TAKELEY STREET ACTION GROUP (TSAG)
FORMAL PLANNING REPRESENTATION

FLOOD RISK & DRAINAGE OBJECTION

Planning Application:
Land North of Taylors Farm

Application Reference:
UTT/25/2786/OP

Fig 1
Directional run of pipes that join inspection chamber SW1 from the East and West.

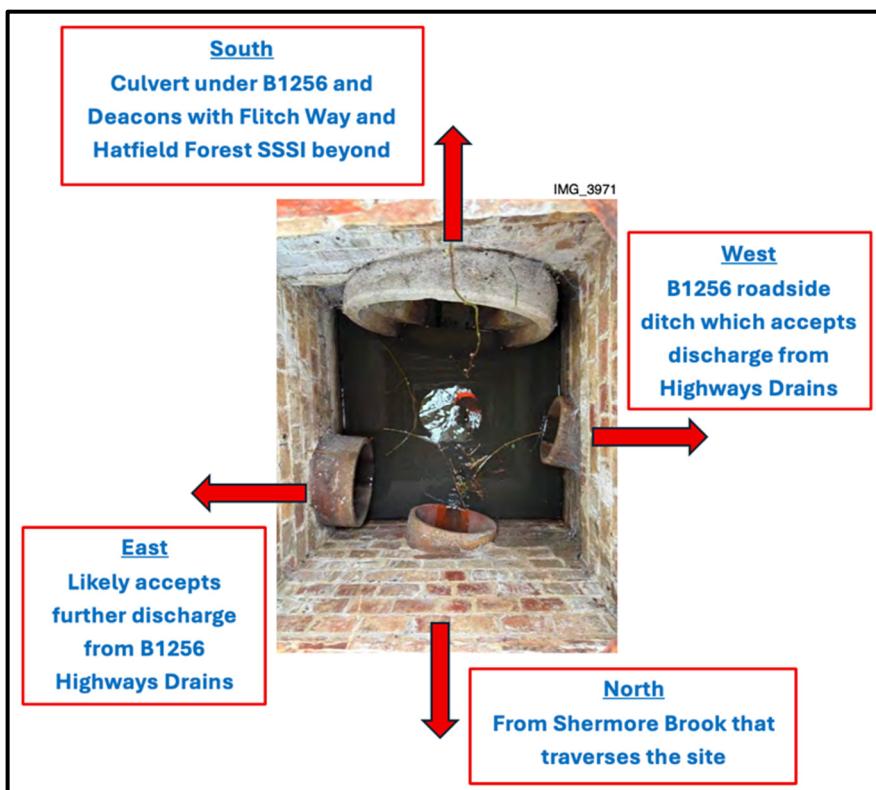
4.6.12 A **significant** and perhaps deliberate omission is that the pipe entering inspection chamber SW1 from the West originates from the Highway ditch bordering the southern boundary of the site. Had the developer disclosed this it would have demonstrated that the culvert under the B1256 and Deacons not only receives water from Shermore Brook and surface water from the site, but that it also receives storm

water from the highway and presumably a higher volume of water than implied in their submission. See Fig 1 & 2.

It makes no sense why all four pipes would not have been CCTV inspected during an inspection. Footage should be submitted as part of the assessment and include the impact of the rainwater from Highways and discharge from all pipes.

Further investigation relating to Highways drain connection is required

FURTHER CLARIFICATION SHOULD BE SOUGHT AS TO THE PURPOSE OF ALL PIPES IN INSPECTION CHAMBER SW1.

Fig. 5.
Land drainage outlet into
Shermore Brook (West ditch)
central to the site.

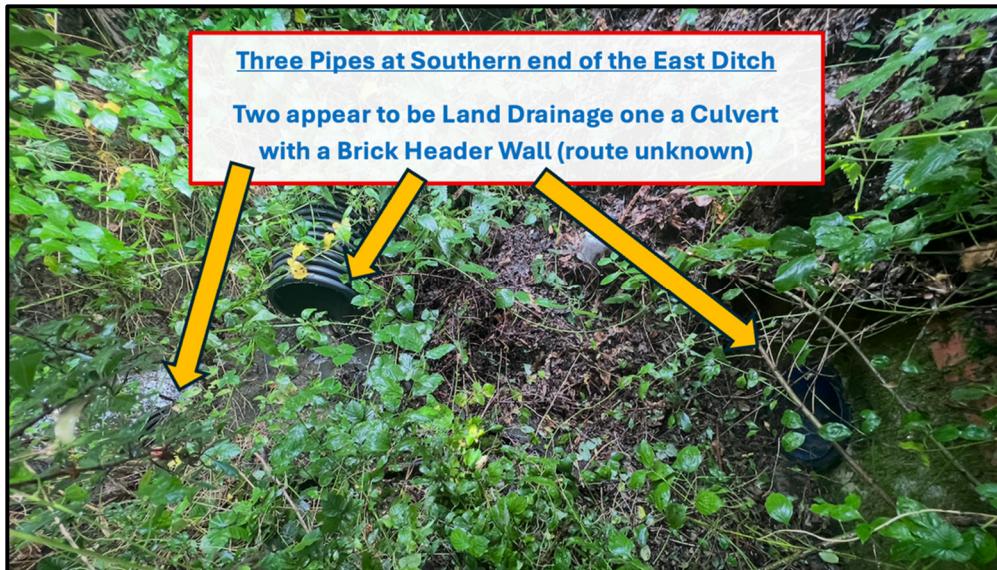
It is not “likely”. There **categorically is** land drainage that was only upgraded in recent years to improve the poor drainage issues relating to this site. It is unclear why the developer has NOT disclosed all land drainage or all culverts. All pipes should all have been CCTV inspected and flow established.

Concerningly one pipe appears to be a further culvert with a brick header wall at the Southern end of the East ditch. Clarification is required on the route, length, condition, where the outfall is, and whether it runs under third party land. See Fig 5, 6,7,8.

Fig. 7.
 Close up of culvert with brick header wall at
 Southern end of East ditch. Route and outfall
 undisclosed.

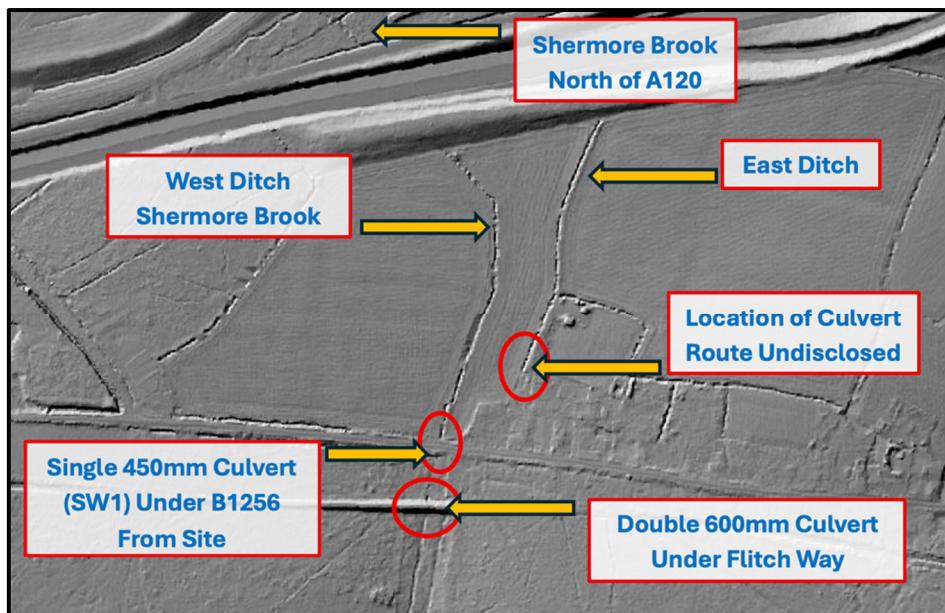
Further clarification required.

Fig. 13.
Shermore Brook route on base mapping.

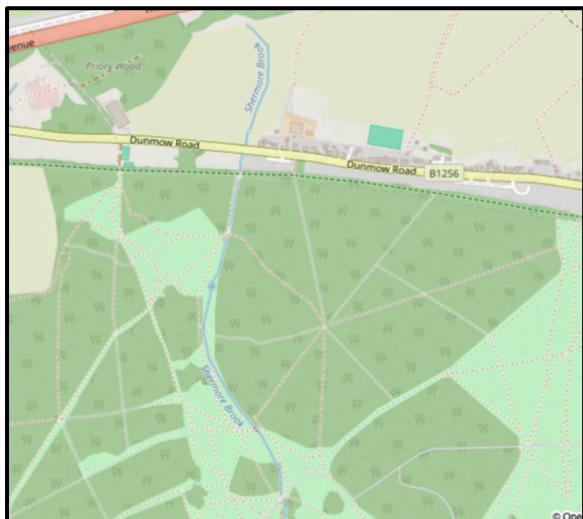
Shermore Brook begins north of the A120 but there are no details available to clarify the route it now takes since the A120 construction but it is probable that there is a culvert below the A120. Clarification is required, particularly since the Developer intends to build over and divert Shermore Brook on site putting Hatfield Forest at risk.

Shermore is the **only** feed for Old Woman's Weaver and Hatfield Forest Lake. It is **NOT** 'dry' most the year as stated by the Developer, who has not provided any evidence to support this statement. Shermore does not dry up where it meets the Flitch Way and flows into Hatfield Forest. If indeed Shermore Brook is dry much of the year within the proposed site, then the Developer must establish the source of the water that evidently does flow all year from the site to Shermore Brook and ultimately ensures the lake does not dry up.

Shermore is clearly marked on historic and modern mapping and specifically can be seen on LiDAR Mapping both North and South of the A120. See Fig 8 (above), 13 to 18 (below).

Fig. 18. Shermore where it enters Hatfield Forest following heavy rain. The culvert visible and functioning as intended.

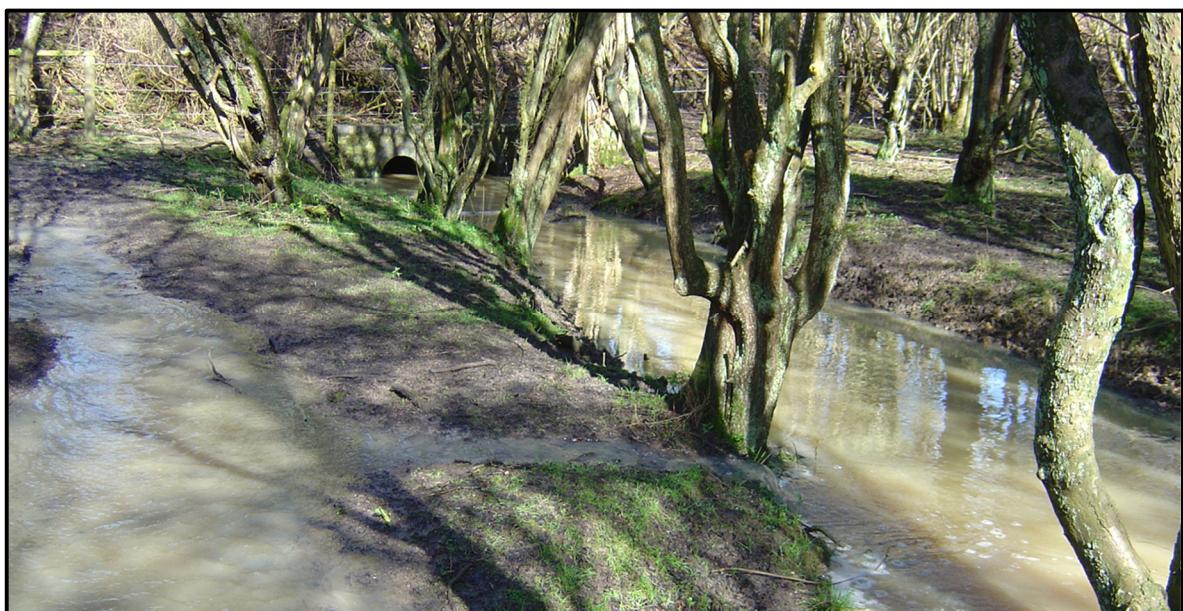
The Developer should explain where the volume of water comes since they state that Shermore is dry most of the time.
